ISSUE: Certificate of Appropriateness for alterations

LOCATION: Old and Historic Alexandria District
105 Queen Street

UPDATE

I. APPLICANT'S PROPOSAL

Figure 1: Original submission for south elevation

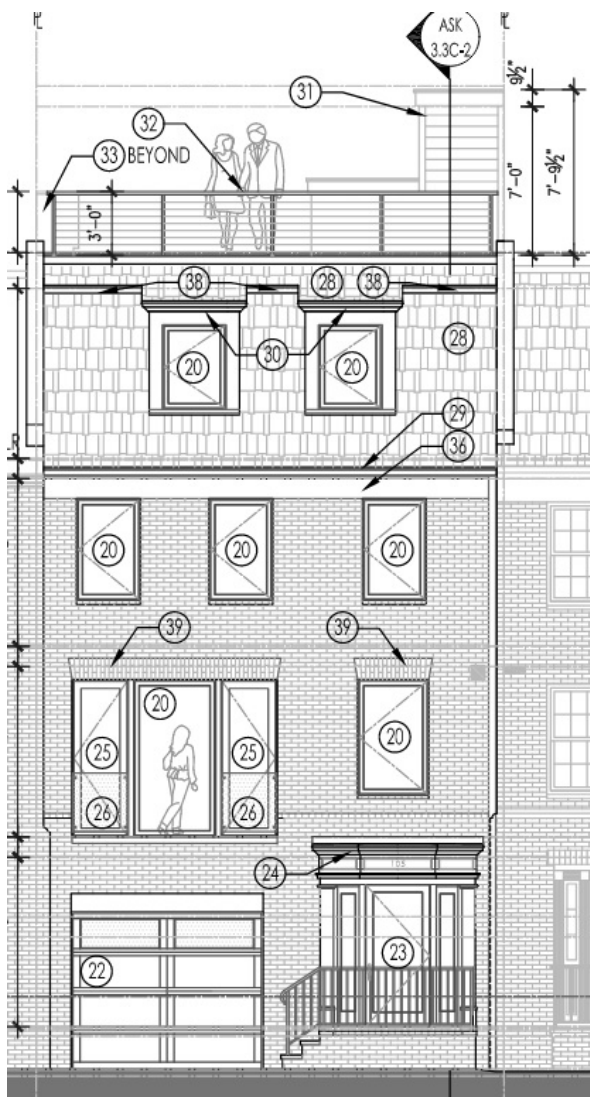
The Board would like to see changes to the proposed front elevation.

Mr. Spencer asked if the proposed dormers would be centered between the windows on the below floors and Ms. Conkey verified that. Mr. Spencer has no issue with the modern look, as these are modern homes. He questioned the entablature over the door, indicating that it should be simplified. Ms. Irwin suggested a metal and glass door canopy instead.

Ms. Irwin moved to approve Option B for the roof deck stair enclosure and defer the entablature and front elevation to align the dormers and change the railings by the front door.

As requested by the BAR, the applicant proposes several changes to the south/primary elevation. These changes include simplifying the entablature over the door, replacing the existing railings, and making various other tweaks to the design. See Figure 1 for the previous submission and Figure 2 for the current submission. The Board specifically suggested a simplified entablature and a metal and glass canopy over the door, both of which are more in keeping with the appearance of the house. The proposed brick jack arch over the door works better with the overall design than the previously submitted Colonial Revival entablature.

Figure 2: Current submission for south elevation

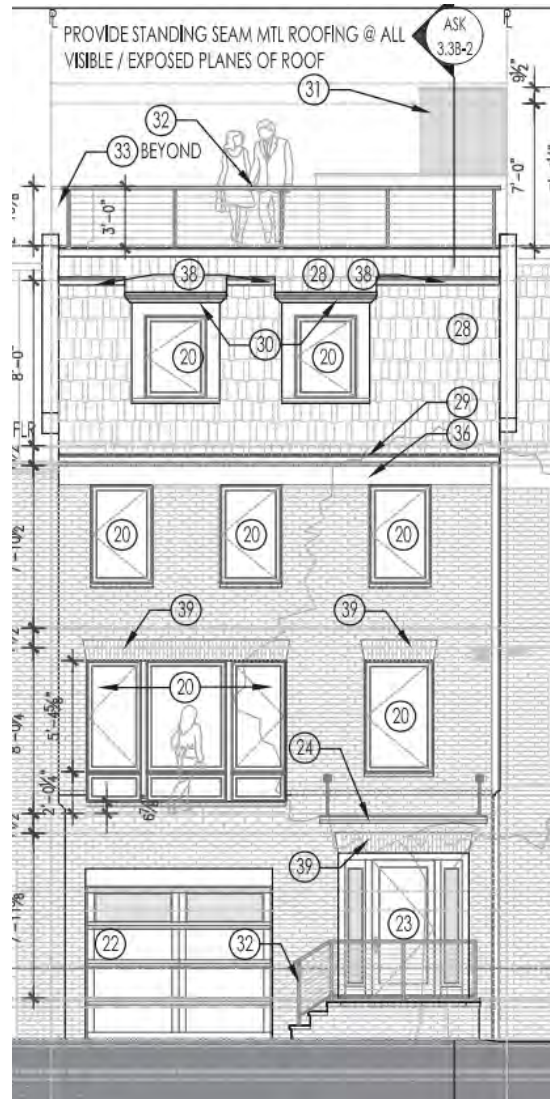
The BAR also requested that the applicant change the railing on the front stoop to match the approved railing on the roof deck. This will now be a painted metal cable railing, more consistent with the overall design than the existing painted wrought iron railing. In addition, much like the canopy and railings, the proposed front door better harmonizes with the rest of the design of the

Figure 2 demonstrates that the third-floor dormers have been shifted slightly to better align them with the second-floor windows below. The dormers are now centered over the gap between the second-floor windows, providing a degree of symmetry to the design. The applicant also proposes simplifying the previously-approved picture window over the garage by removing the proposed doors and railings. This window will now be composed of fixed casement windows from the same Marvin Ultimate collection approved in the prior hearing. These comply with all window specifications. While the proposed metal and glass garage doors are not wood, which the *Design Guidelines* specify as a preferred material, the Board approved the steel doors at the prior hearing, and the proposed doors are "...appropriate to the architectural character and materials of the garage."

Staff recommends approval of the project with the condition that the glass in the door sidelights be clear, non-reflective, and without tint.
